Service Letter No. 329A (Supersedes S. L. 329)

SUBJECT: Inspection of Oil Cooler Lines, Oil Cooler Line Securing Clamps and Oil Cooler Line Attachments to Oil Radiator

MODEL AFFECTED: PA-22 - Serial Nos. 22-3886 to 22-6879 inclusive

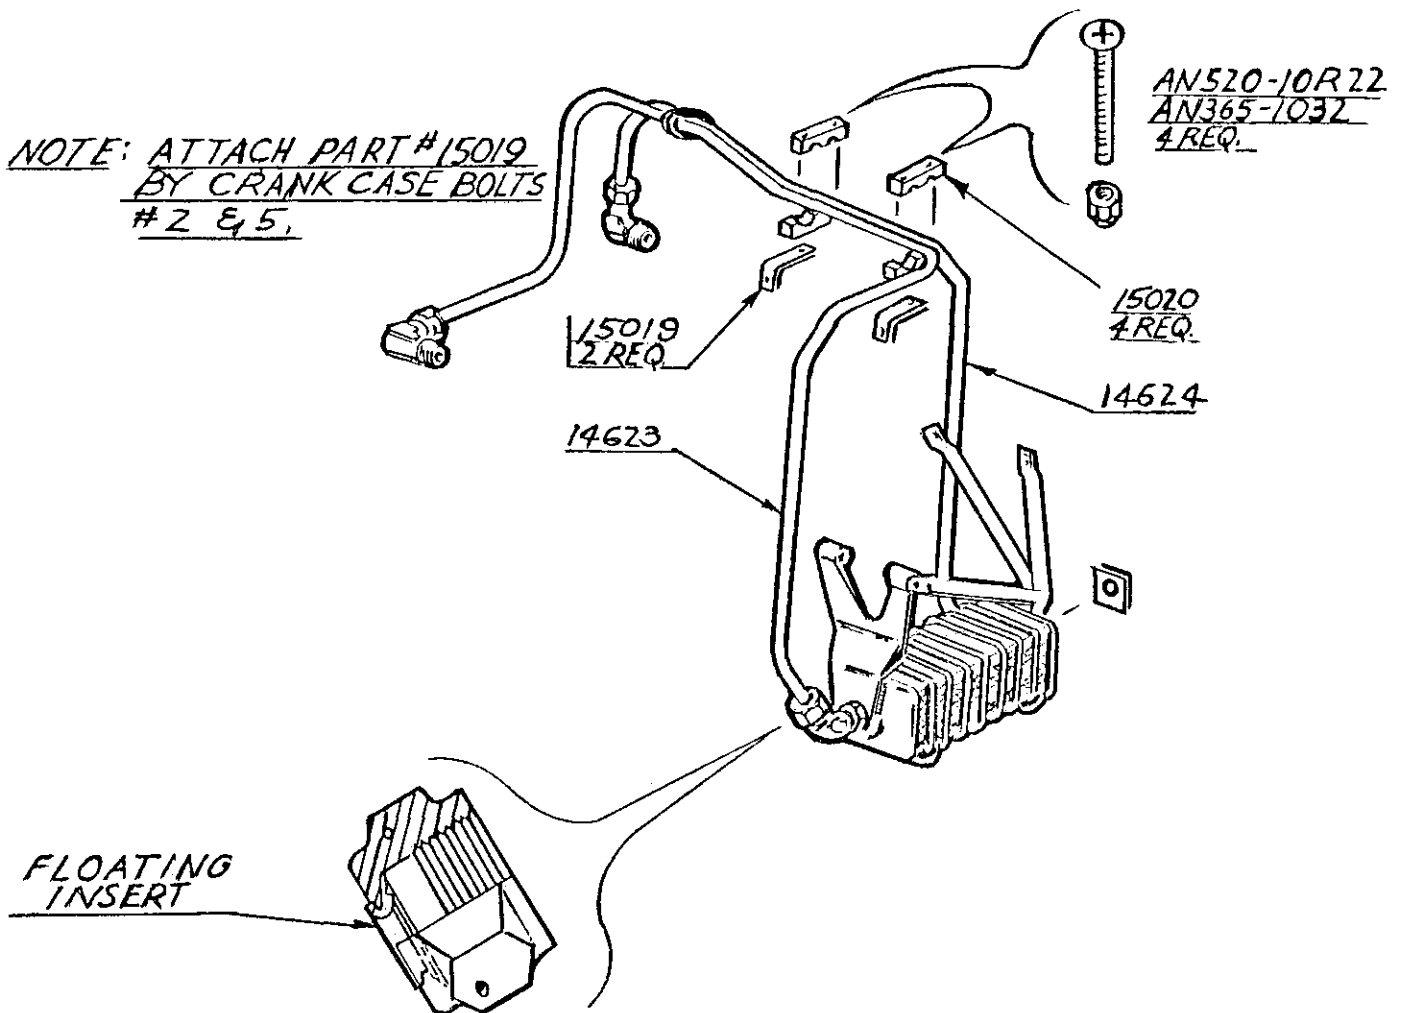
Serial Nos. 22-6760, 22-6761, 22-6763 and up were equipped with improved oil line retaining blocks, part number 15020-00, and brackets, part number 15019-00. These will aid in further reducing the effects of misalignment and vibration. We recommend the installation of the new type retaining block and bracket on Serial Nos. 22-3886 to 22-6759 inclusive and 22-6762. See Sketch on reverse side.
